WAGERUP REFINERY UNIT THREE

ENVIRONMENTAL REVIEW AND MANAGEMENT PROGRAM

Response to Public Submissions

ALCOA WORLD ALUMINA AUSTRALIA

Figure 12: 2004 Visual Amenity Plantings Farmlands Residue Amenity Plantings provide further screening from the North of the Residue Area.

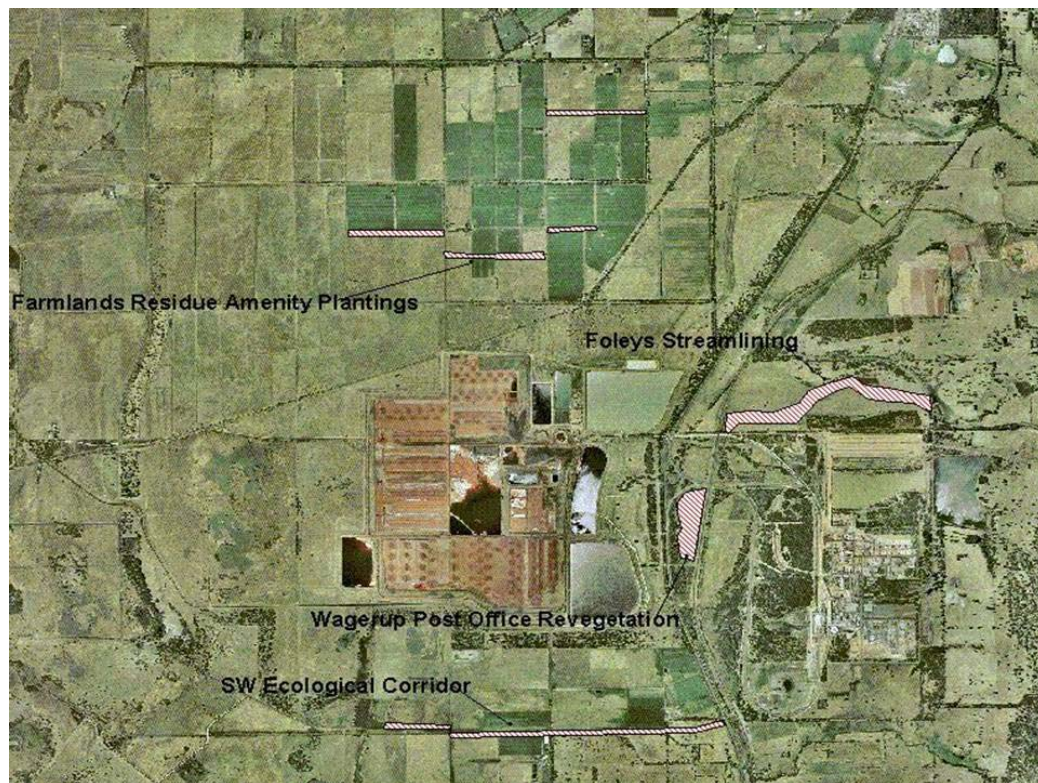
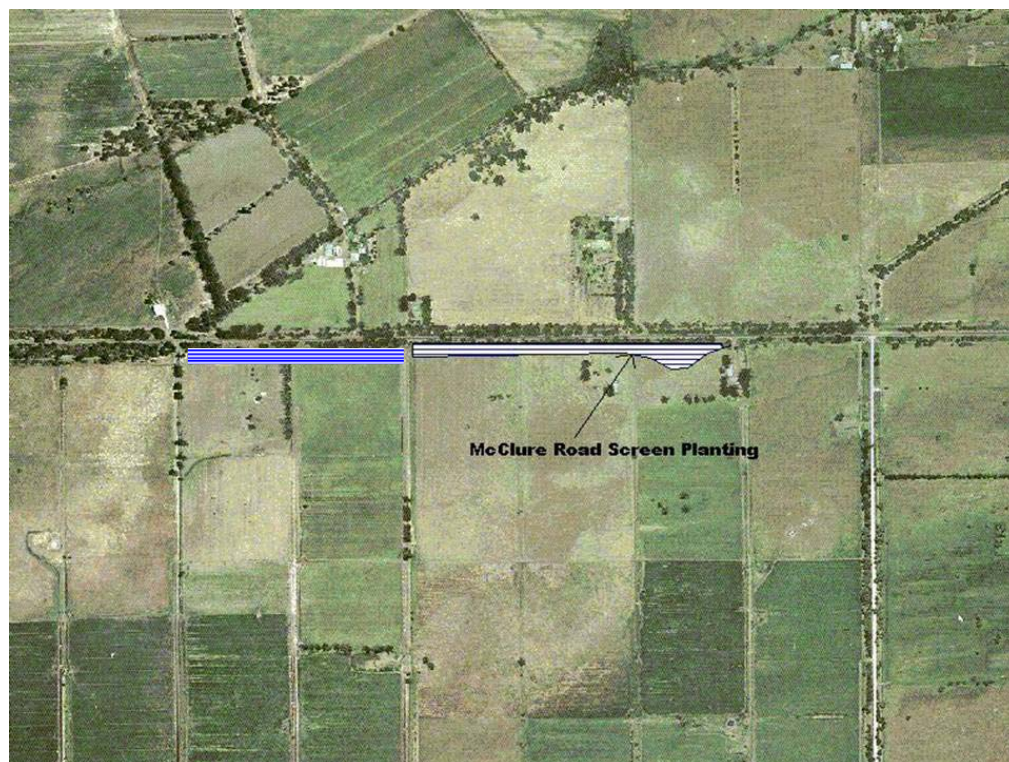
3.14.2 Increased visual amenity impacts of RDA

In 2004, tree lines comprising indigenous species to enhance biodiversity (refer to Figure 12) were planted to break up views from McLure and Somers Roads. The survival rate of this planting was at 60 – 70 percent in August 2005.

To enhance residue screening and amenity value of the immediate area, the 2005 planting program included further planting along McLure Road and infill planting along Somers Road. Advice from community members involved in the planting program review conducted in 2004 saw the McLure Road planting area extended west to a point where the irrigation channel crosses under McLure Road (refer to Figure 13). Community members and Alcoa identified significant drainage problems along Somers Rd that affect tree survival due to inundation during winter. Species that can survive wet, clayey conditions have been targeted for the infill planting along Somers Rd, but success of these plantings is not guaranteed. These areas were planted during 2005 and survival rates will be assessed in 2006.
